# HISTORIC AND DESIGN REVIEW COMMISSION

**HDRC CASE NO:** 2020-313  
**ADDRESS:** 607 E LOCUST  
**LEGAL DESCRIPTION:** NCB 1735 BLK 14 LOT 3  
**ZONING:** MF-33,H  
**CITY COUNCIL DIST.:** 1  
**DISTRICT:** Tobin Hill Historic District  
**APPLICANT:** Luis Botello/ASTER DEVELOPMENTS LLC  
**OWNER:** Luis Botello/ASTER DEVELOPMENTS LLC  
**TYPE OF WORK:** Amendment to previously approved materials for new construction  
**APPLICATION RECEIVED:** July 02, 2020  
**60-DAY REVIEW:** Not applicable due to City Council Emergency Orders  
**CASE MANAGER:** Stephanie Phillips

The applicant is requesting a Certificate of Appropriateness for an amendment to a previously approved exterior material palette for the new construction at 607 E Locust. The applicant is seeking approval for the use of a hybrid composite wood siding for a portion of the structures.

RENDERING WITH PROPOSED MATERIAL

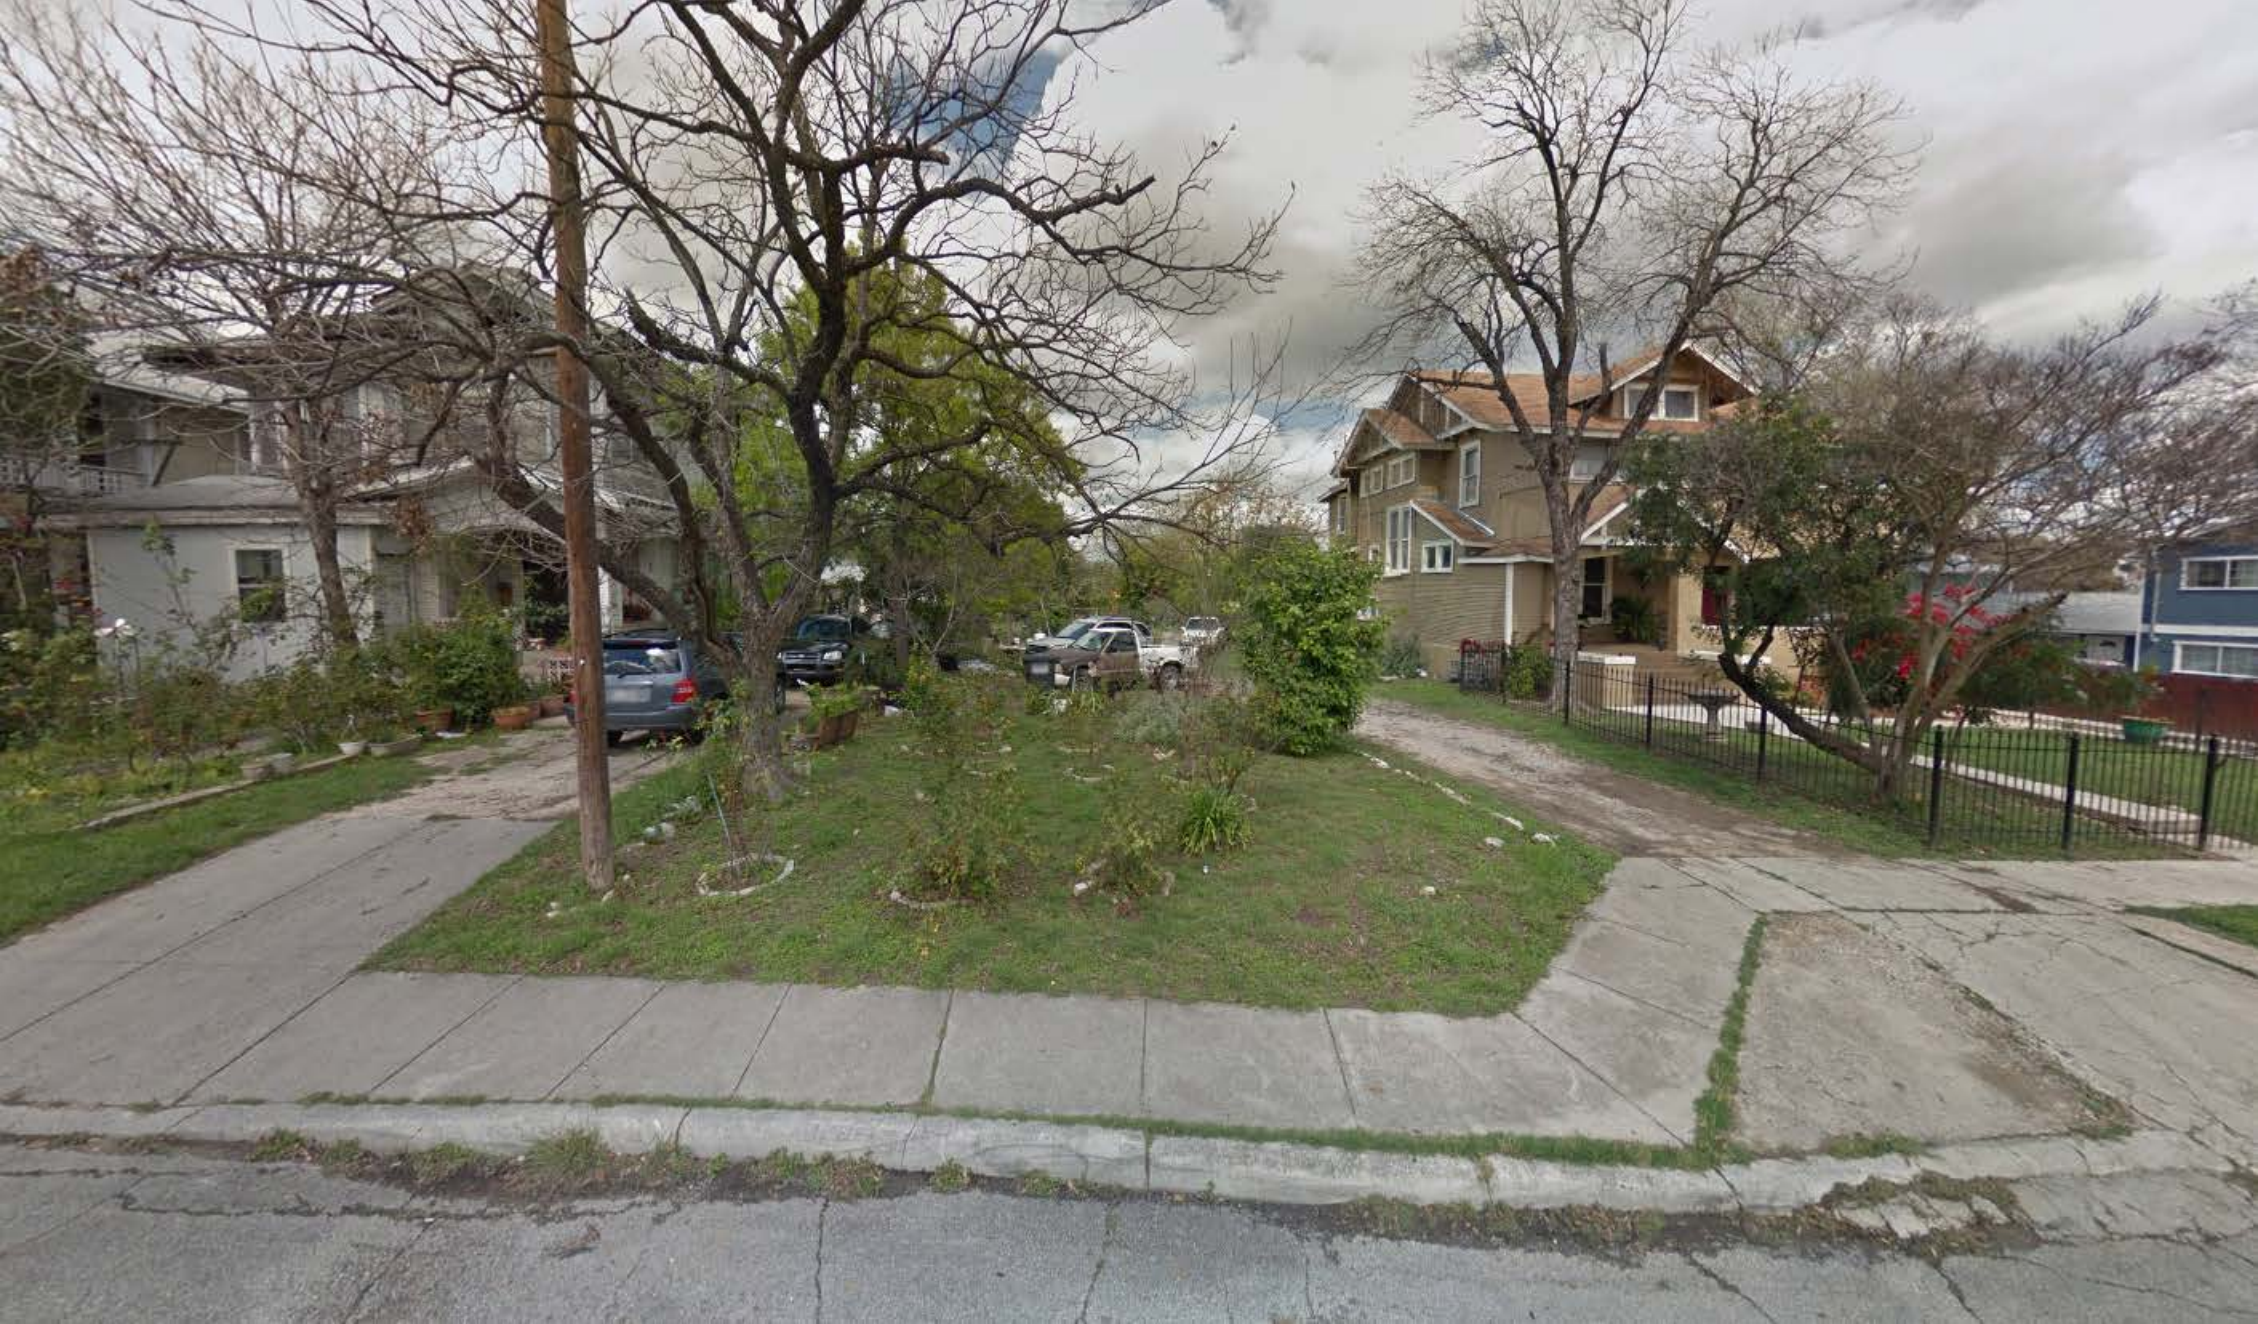
- b. MATERIAL AMENDMENT – The applicant is requesting a material amendment to allow for the use of a hybrid composite wood siding product as a secondary exterior siding material. The primary material will remain smooth vertical Hardie composite siding. The new material will be vertically oriented and will continue to the undersides of porches and overhangs. The product is visually similar to sealed cedar siding. The product is used in a similar secondary application at 416 Kendall, a block from this location, in the new construction of a single family residence. According to the Historic Design Guidelines, contemporary materials not traditionally used in the district, such as brick or simulated stone veneer and Hardie Board or other fiberboard siding, may be appropriate for new construction in some locations as long as new materials are visually similar to the traditional material in dimension, finish, and texture. Additionally, the Guidelines encourage integrating contemporary interpretations of traditional designs and details for new construction, which can provide visual interest while helping to convey the fact that the structure is new. Modern materials should be implemented in a way that does not distract from the historic structures in the district. Based on the proposed secondary implementation of this material - which features a traditional dimension, finish, and texture to a historic material – as well as its relationship to architectural features in the design, including porches and overhangs, staff finds the request appropriate for this specific new construction project.

Staff recommends approval based on findings a and b.
